Proposed Redevelopment 485 Ancaster Avenue, Ottawa

Assessment of Adequacy of Existing Municipal Services

City File No: D02-02-18-005

**Reference: 485 Ancaster Avenue
Zoning By-law Amendment Application – Response to Comments
Assessment of Adequacy of Existing Municipal
Our File No. 118035**

EXISTING CONDITIONS PLAN

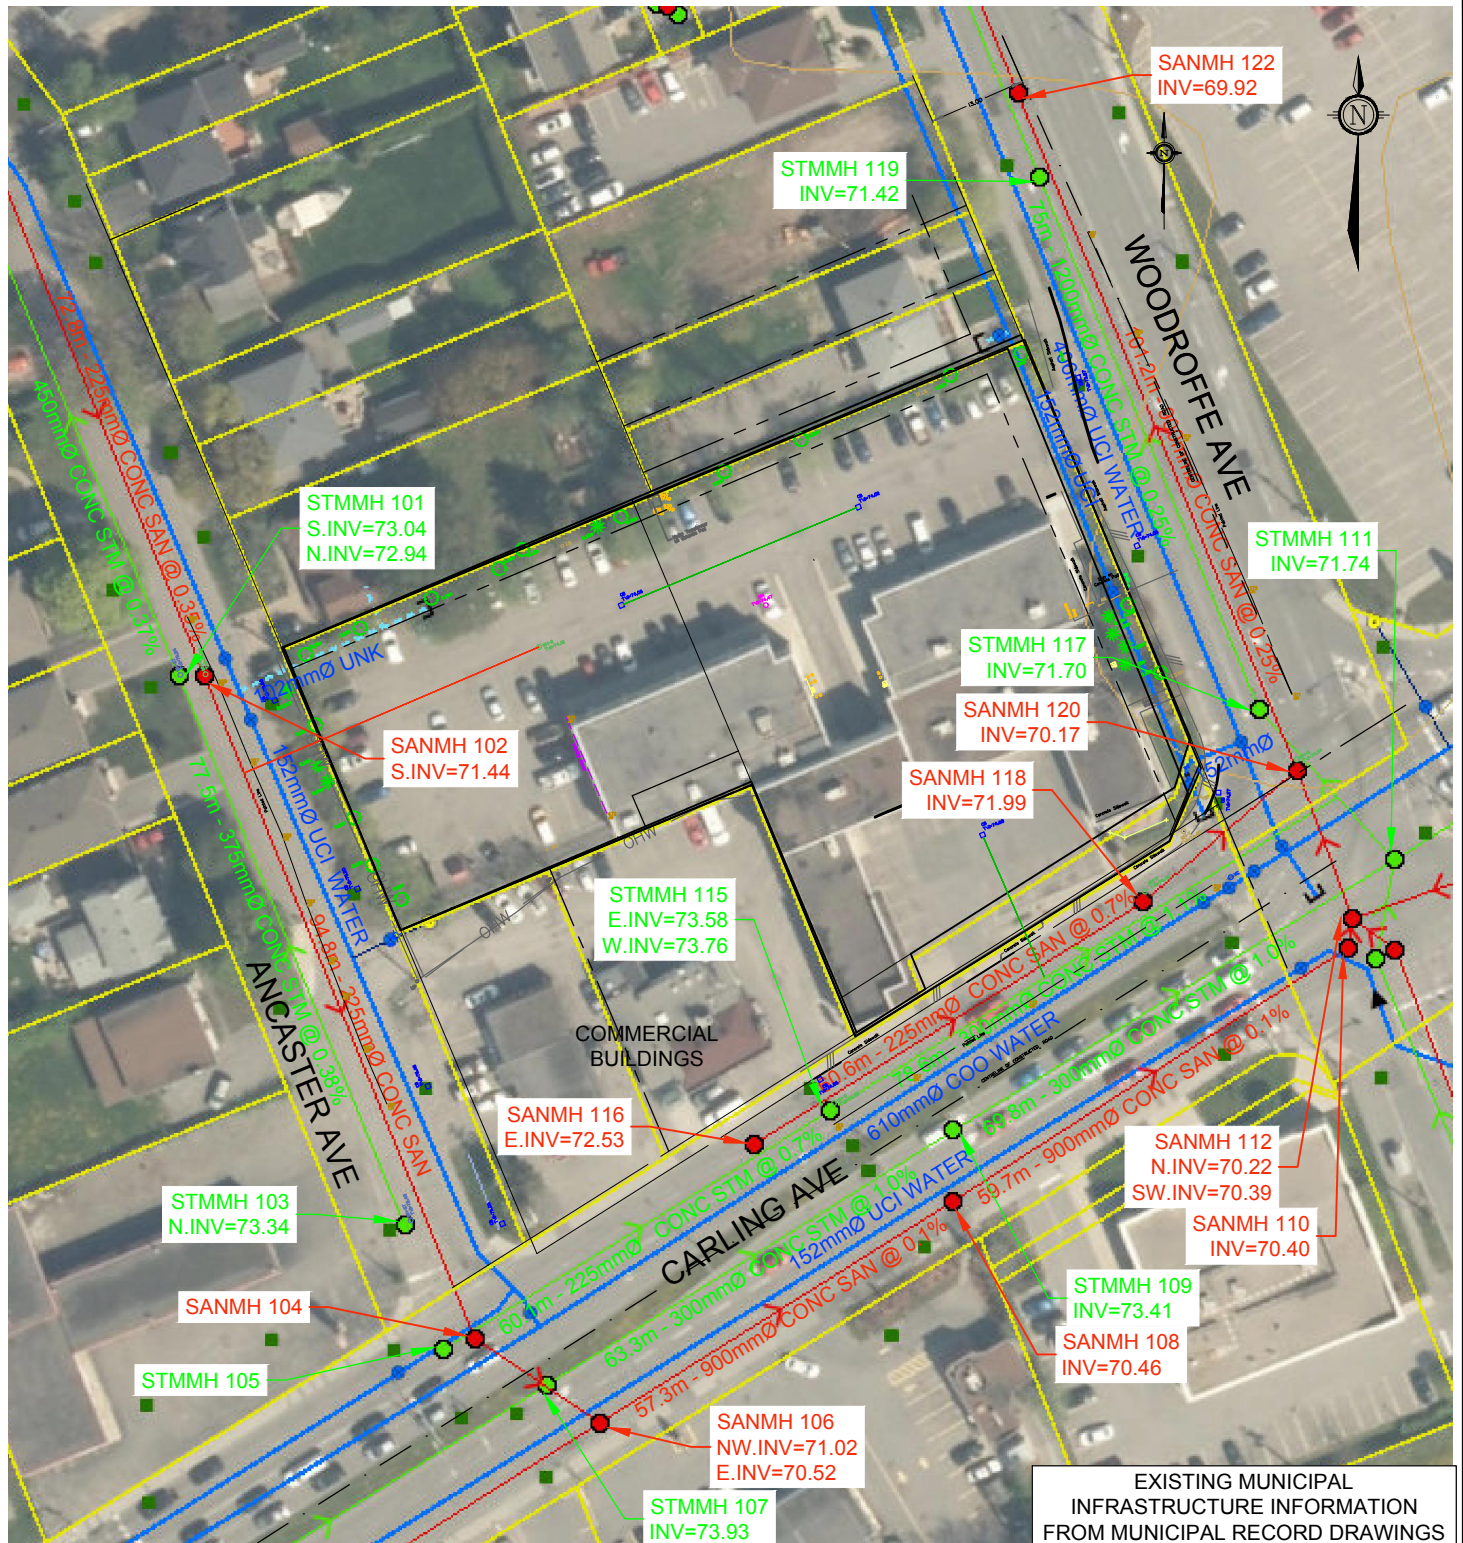
- *We confirm receipt of the March 5, 2018 email.*
15. Please provide an Existing Conditions Plan to document how the subject site is currently serviced.

- *Refer to Figure 3 in the Report. Exact locations of existing services will be determined at the detailed design stage.*
16. In addition to GeoOttawa please obtain as-built drawings to establish/confirm the existing municipal services adjacent to the subject site and invert information. Please provide as-built drawings for the adjacent municipal services on Ancaster Ave., Carling Ave. and Woodroffe Ave. These documents can be requested and obtained through the Information Centre.

- *As-built drawings have been requested and received from the City and are attached to this response letter. The as-built inverts have been added to Figure 3 in the Report.*

PRE-DEVELOPMENT DRAINAGE AREA PLAN

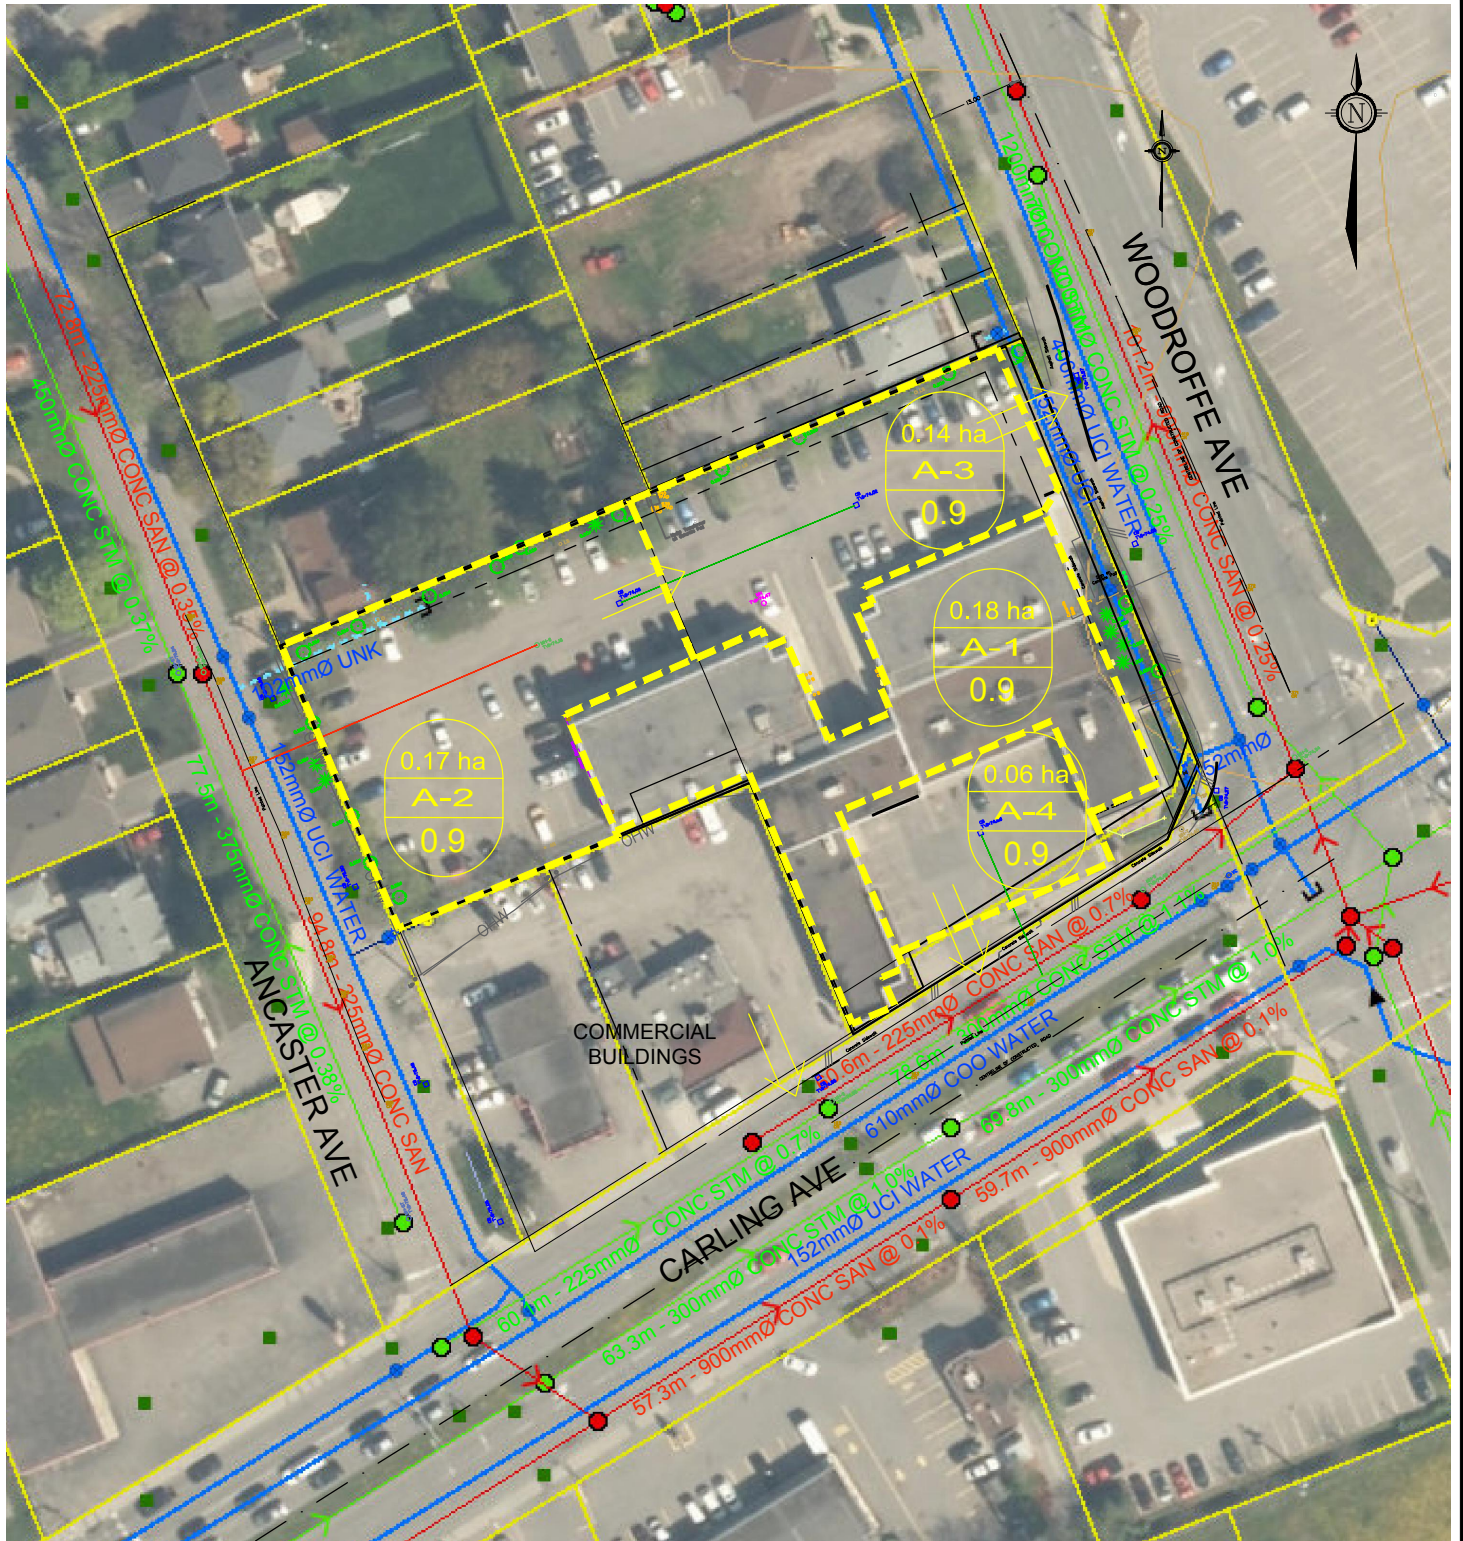
- *Noted.*
32. Please provide a Pre-Development Drainage Area Plan to define the pre-development drainage areas/patterns.
- *Refer to Figure 5 in the report for pre-development drainage patterns.*

13. On the Pre-Development Drainage Area Plan please identify the direction of overland flow.

- *Additional overland flow arrows have been provided on Figure 5.*
